Feedback on the George Street/Bank Street Connection Project

Thank you for the opportunity to engage in the design phase of the George Street/Bank Street Connection Project.

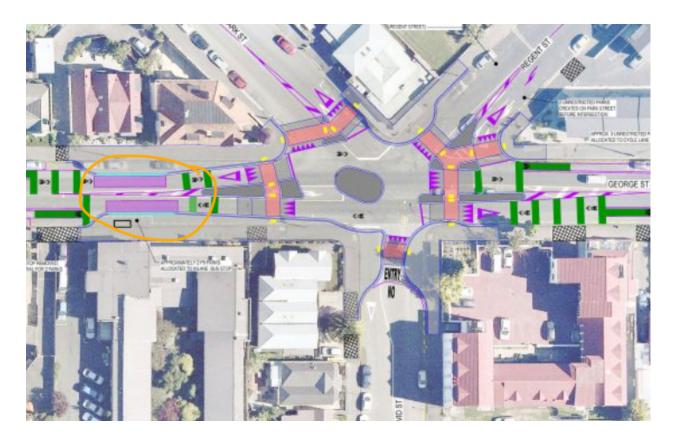
**The exception to the support is the diversion of the cycle lane onto the footpath. This is due to a commute cycle speed of 20-30km/hr. It is my opinion the cycle path should be shared with the

bus, rather than pedestrians so I don't recommend diverting the cycle path behind the bus stop, particularly outside George Street Normal School.

Cars don't like cyclists in the vehicle lane when there is a cycle lane, but at 30km you can't ride with pedestrians, and I would drop into the vehicle lane, provoking 'anger'. I will out-ride a bus in the cycle lane up/down George Street. You can pass the bus (subject to traffic) if it is stopped. Also, there is a fixed pool of bus drivers who will adjust to sharing the lane with cyclists (and vice versa).

So if the cycle diversion behind the bus stop is not changed, I prefer OPTION 1(no cycle lane).

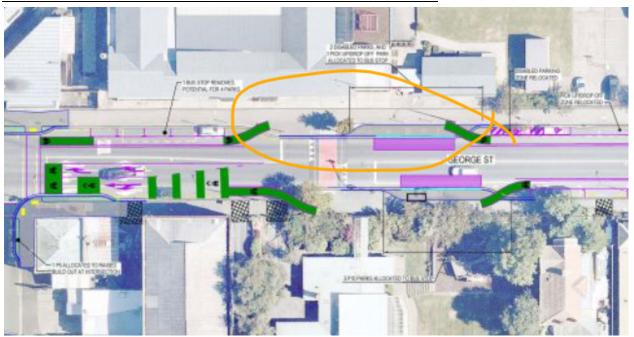
- Cycleway along the length of George St, both ways. Southbound bus stop outside #516 removed. <u>DO NOT SUPPORT. Prefer Bus stop #521 north and #516 south.</u>
 Otherwise, there are effectively three blocks without a bus stop (south end of Knox Block, then at 677 George Street. THIS IS NOT REASONABLE

- 2. Cycleway continues, kerb build-outs at the intersection corner. **SUPPORT.**
- 3. Bus stop removed outside Allan Court Hotel going south, and bus stop removed outside 607 George St. *ONLY SUPPORT IF BUS STOP AT #521*

- 4. Cycleway <u>MERGES</u> onto road to enter roundabout, continues as cycleway exits roundabout. <u>SUPPORT</u>
- Bus stop outside 664 George St moved slightly north to 678 George St. New bus stop outside 677 George St going north. <u>DO NOT SUPPORT DIVERSION ONTO</u> FOOTPATH

- 6. St David St becomes one way. **SUPPORT**
- 7. Cycleway continues, raised crossing at intersection of George St and Dundas St with kerb build-outs. *SUPPORT*

- Bus stop removed outside 896 George St, moved slightly south to outside 818 George St. Bus stop added outside 847 George St. Cycleway moves onto road to enter intersection. <u>DO NOT SUPPORT DIVERSION ONTO FOOTPATH</u>

- 9. Kerb build-outs at intersection, raised pedestrian crossing on Howe St. Bus stop removed outside George St Normal School and moved slightly more north (still outside the school). **DO NOT SUPPORT DIVERSION ONTO FOOTPATH**
- 10. Disabled parking zone and pick up/drop off zone relocated slightly further north down the street (still outside the school). New bus stop outside 950 George St (replaces bus stop at 974 George St). SUPPORT BUS STOP RELOCATION
- 11. Kassel kerbs for both bus stops allow cyclists to continue on path behind bus stop. *This* is *HIGH risk. DO NOT SUPPORT DIVERSION ONTO FOOTPATH*
